Subject: Indian Point 3 Nuclear Power Plant
Docket No. 50-286
Environmental Qualification Safety
Evaluation Report - 30-Day Response
Information

RESPONSE TO NRC
EQ SER
OF DECMEBER 30, 1982
AS CLARIFIED BY LETTER
DATED APRIL 28, 1983

NEW YORK POWER AUTHORITY
INDIAN POINT 3 NUCLEAR POWER PLANT
DOCKET NO. 50-286
JUNE 1983

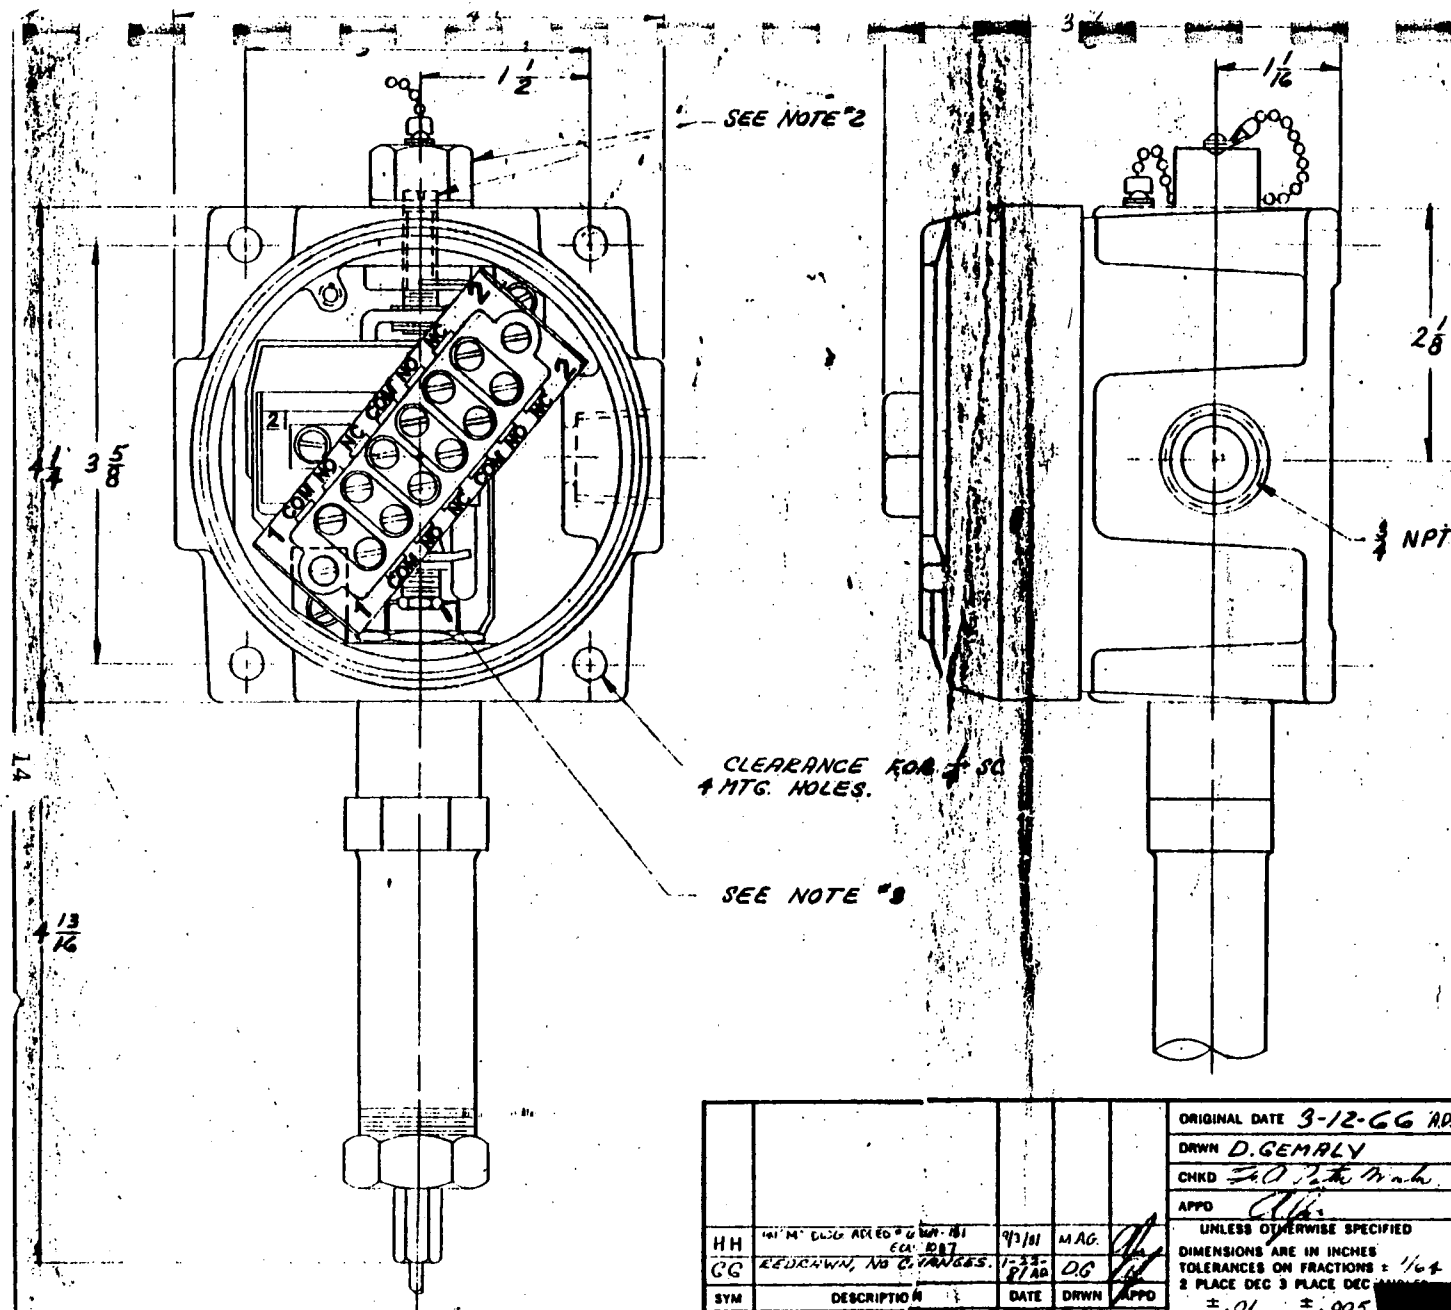
FAILURE MODE ANALYSIS (see Figure 1)

The only possible mode of failure would be for steam from a break in the AFP turbine steam supply to infiltrate the housing and provide a conducting path between adjacent wires in the terminal block and cause a short circuit which could prevent valve closure. Since the conductor in the wires is not exposed, the distance between the screws is greater than 1/8 inch and steam is a poor conductor, bypassing of the switch is highly unlikely. In addition there is negligible probability that steam could be admitted to the switch internals because threaded joints and conduit paths are highly restrictive and the switch would actuate long before

The only way that steam could enter the internals of the switches would be via the housing cover threads, the conduit connection threads, or through the cable end of the conduit. All of these paths are extremely restricted and would require high pressure to force steam into the unit. Because each temperature switch is set to trip one of the isolation valves at 135°F, the steam supply would be isolated before any steam could enter through the threaded connections. Therefore, operation of the devices is assured.

The threaded connections and conduit will be sealed using teflon tape for the housing cover and RTV 77 for the conduit and cable entry areas. Use of teflon tape was qualified by LOCA tests on NAMCO EA 180 and EA 740 limit switches, and RTV was qualified by LOCA tests on conduit outlets sealed with RTV in Wyle test for J. A. Farley Plant (Wyle Report #44354-1, page 6, Test Item 4).

When completely sealed from steam, the devices are qualified for the temperature and humidity and have no materials that will degrade at the normal ambient temperature in the AFP room (104°F max).

FIGURE 1

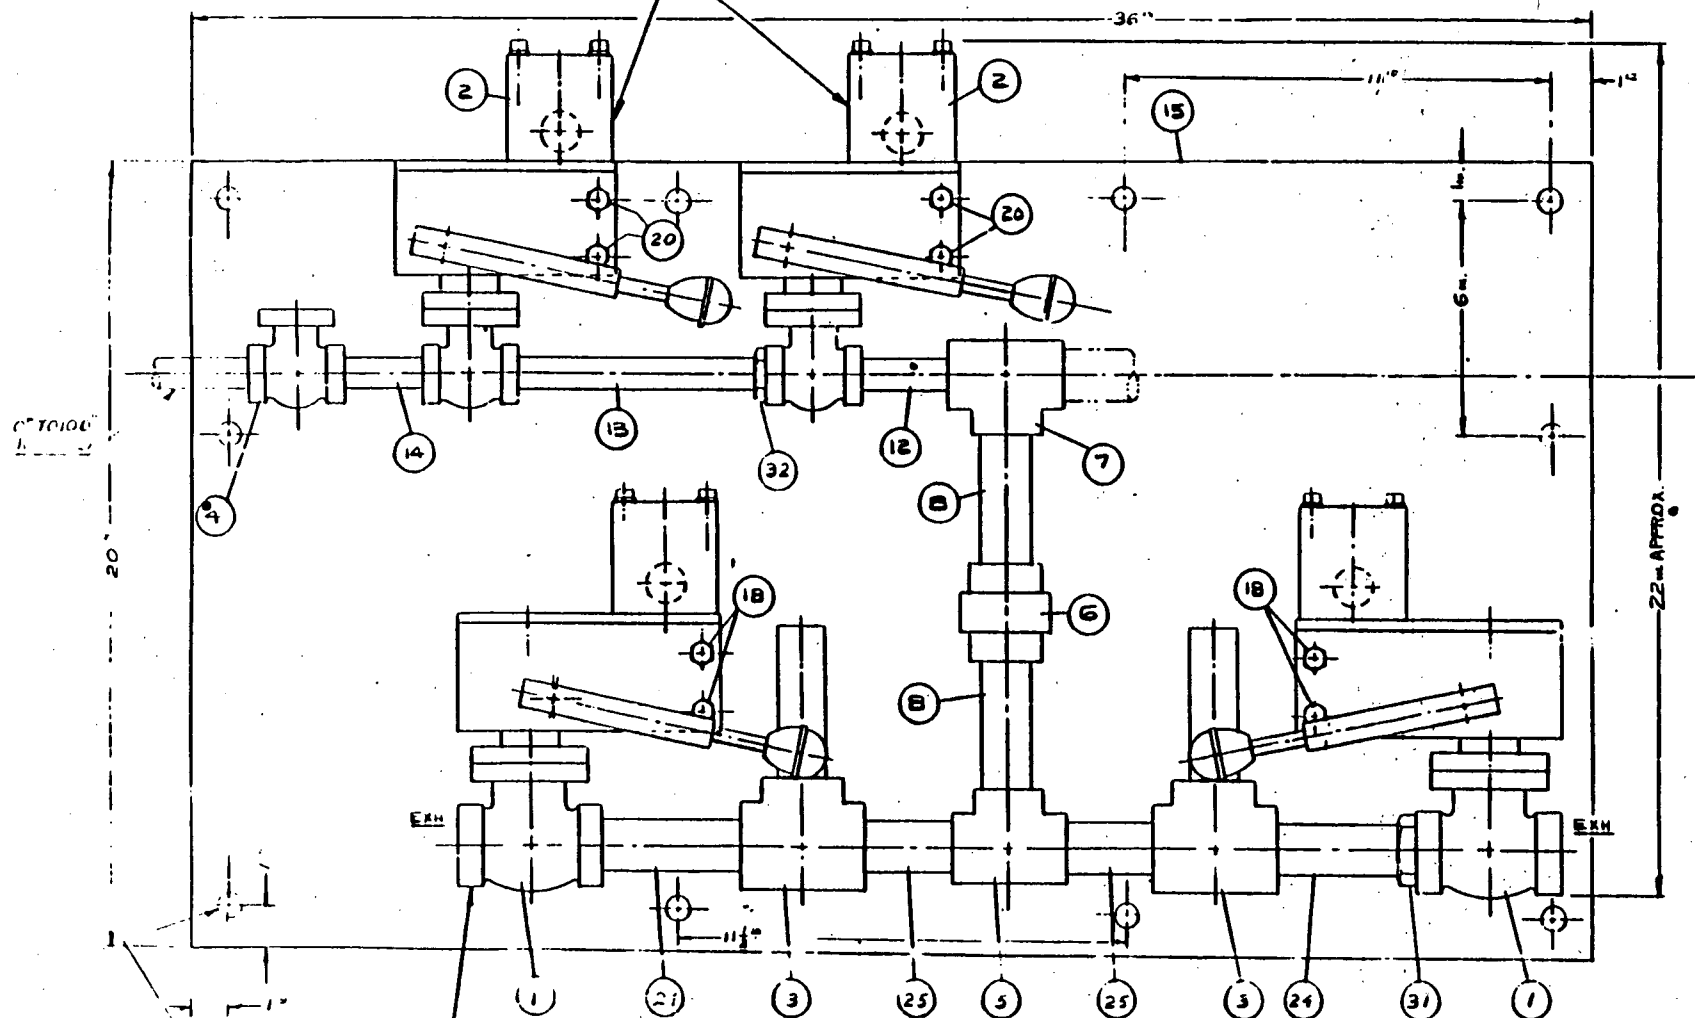
The Laurence SOV's are part of a packaged operating system supplied with the main steam isolation valves (MSIVs). Figure 1 shows the configuration and provides a description of the system operation. Figure 2 shows schematically the power supplies for the solenoid valves, demonstrating that the redundant SOV's shown on Figure 1 are powered from separate buses, and that the system therefore is not subject to a single disabling failure.

- 1) Failure of spring (D).
- 2) Open or short-circuit in solenoid coil or coil connections.
- 3) Binding or sticking between the lever (A) and latch (B).

Additional analysis and or testing will be done to demonstrate qualification of the SOV's. If necessary the valves will be replaced by qualified valves at the first refueling outage following receipt of the replacement units.

FIGURE 3

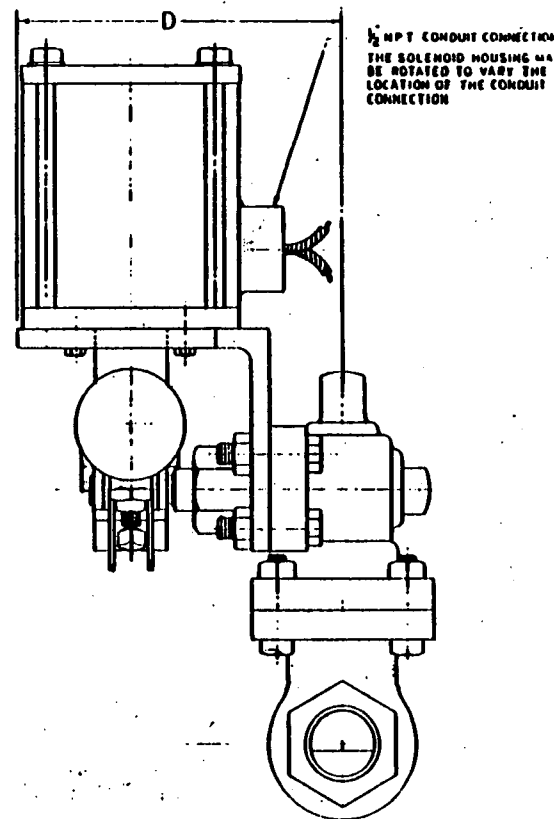
Figure 3 is an assembly drawing of a Laurence SOV. The configuration corresponds to the supply valve of Figure 1. In normal operation

the lever arm (A) is held in the open position by latch (B). The spring (C) holds one latch in position. In this configuration the solenoid is deenergized and the valve plug (F) is held off the seat against the force of spring (D). When the solenoid coil is energized the plunger (E) is pulled upwards, disengaging the latch (B) from the lever arm (A). Spring (D) then forces the valve plug (F) to the closed position.

The only failures which would prevent the valves from performing their function (refer to Figure 3) are:

1) Failure of Spring (D). The drawing (Figure 3) states that internal parts are type 303 stainless steel (viz., plug (D), spring (F) and washer (G)), and the fluid is air. At normal ambient temperatures, the corrosion of stainless steel in air is negligible. Operating experience with installed valves at Indian Point 3 for a period of about 6 years has shown no spring failures in 16 valves when periodically tested as required by the Technical Specifications. Even if the spring force should be reduced, the weight of the lever arm (A) and the direction of flow would provide the necessary force to move the valves to their proper positions.

- 3) Binding or sticking between the lever arm (A) and latch (B). If high friction from metal-to-metal contact between the latch and lever arm (or between the latch and the solenoid plunger) occurred, the coil force to cause valve actuation would increase. If friction forces resulted in binding, the solenoid would not produce sufficient force to actuate the valve. To preclude such events, the moving parts of the operating mechanism are periodically lubricated. They are also tested as required by the Technical Specifications to demonstrate operability.
